## Response to Advisory Board Comments

Site plan with Hilton Garden Inn and 300 East Main at Full Build-Out

**300  
EAST  
MAIN  
STREET**

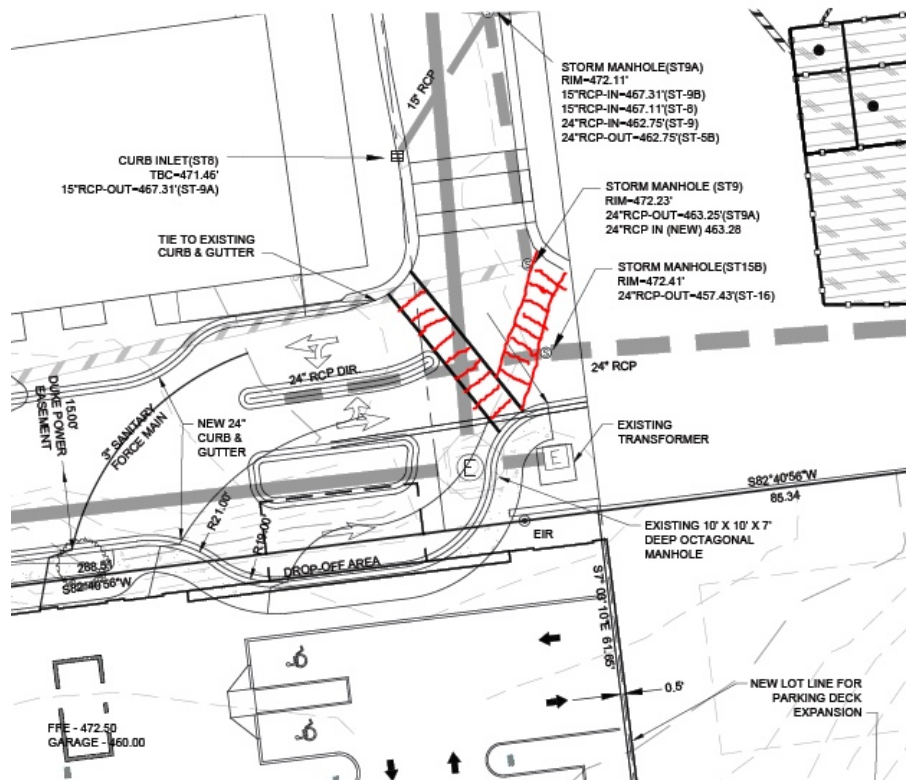
7. Thank you for redesigning the crosswalk in front of the hotel entryway. It is better than it was previously, but please consider making it a high visibility crosswalk instead of just two lines. Additionally, the TAB would like to see another crosswalk running diagonally from the northeast corner of the hotel/ parking deck 'intersection' to the base of the existing crosswalk so pedestrians coming along that side of the street are not stranded (see rendition below).

The plans now show a high-visibility crosswalk. The second crosswalk shown in the TAB drawing is not included because with the vehicle traffic entering and exiting the parking deck it would not be a suitable path for pedestrians. Pedestrians approaching the Hilton Garden Inn from that side of the driveway can cross at the existing bricked crosswalk shown just north of this area.

**1** OVERALL SITE PLAN AT BUILDOUT  
SD1 SCALE: 1" = 40'-0"

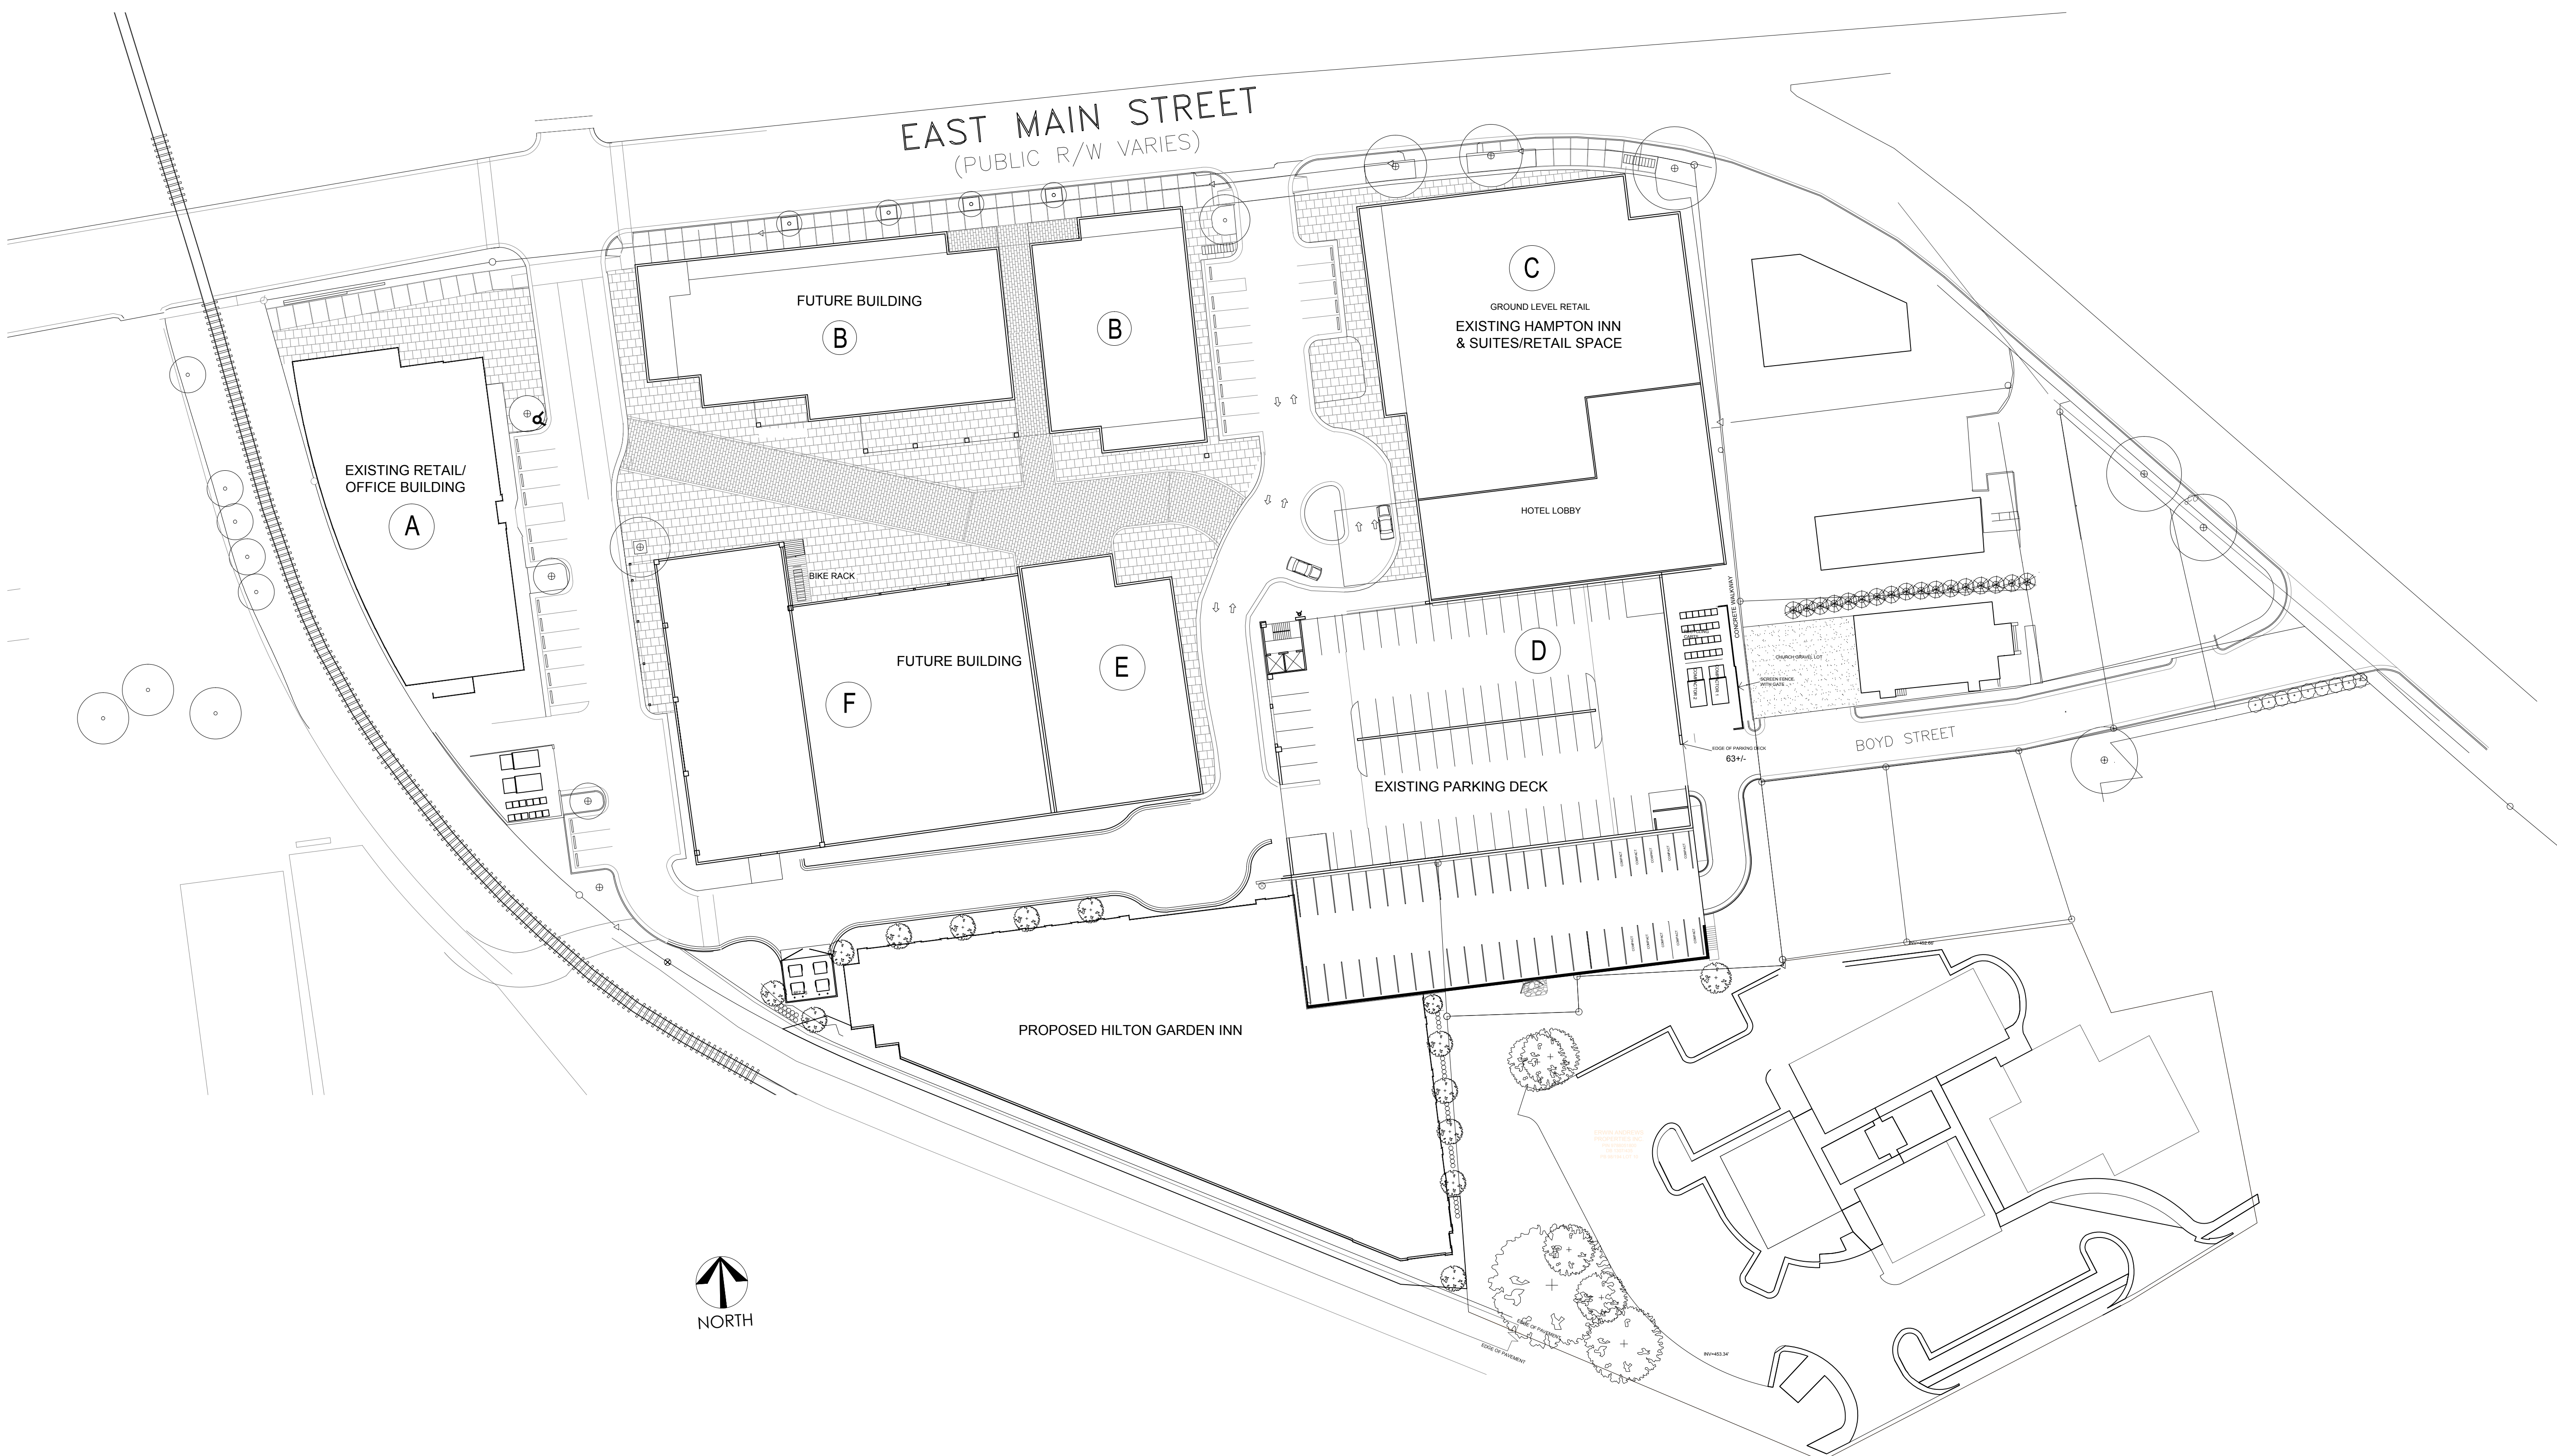
- This lot is an addition to the 300 E. Main St. project. The applicant should show us how this new lot and the proposed hotel will work in the overall design of the entirety of 300 E. Main when it is built out.

See attached site plan.
